DEPARTMENT OF ENERGY

10 CFR Parts 429 and 430

Energy Conservation Program: Test Procedures for Central Air Conditioners and Heat Pumps

ACTION: Final rule.

Figure 1—Climatic Regions I through VI for the United States

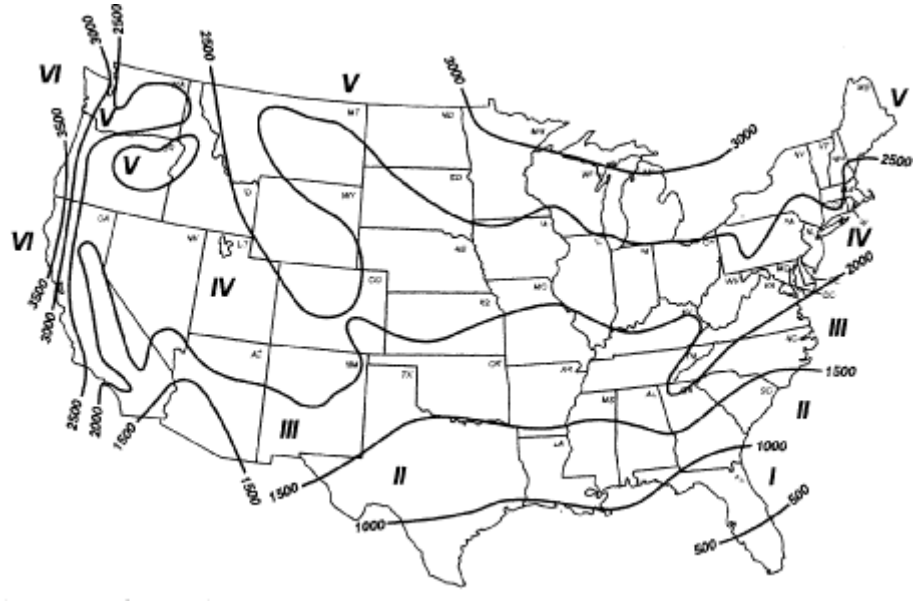
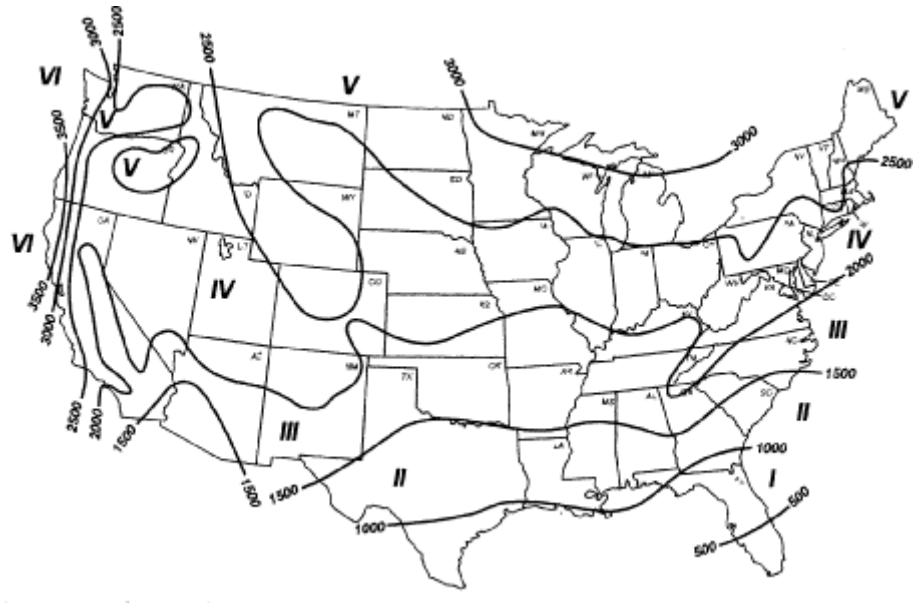
DOE also notes that, in the August 2016 SNOPR, the heating load hours depicted in Figure 1 are not consistent with the new heating load line analysis. 81 FR at 58267 (Aug. 24, 2016) However, the figure is still helpful for depicting the climate zones. Therefore, in this final rule, DOE is renaming Figure 1 to indicate that the figure depicts climate zones rather than heating load hours. In addition, Figure 2, which depicts cooling load hours, is not referenced by any part of the test procedure as modified by the June 2016 final rule and the August 2016 SNOPR proposals. 81 FR at 37119 (June 8, 2016) and 81 FR at 58267 Hence, DOE is removing this figure to reduce potential confusion regarding its applicability to the test procedure and calculations.
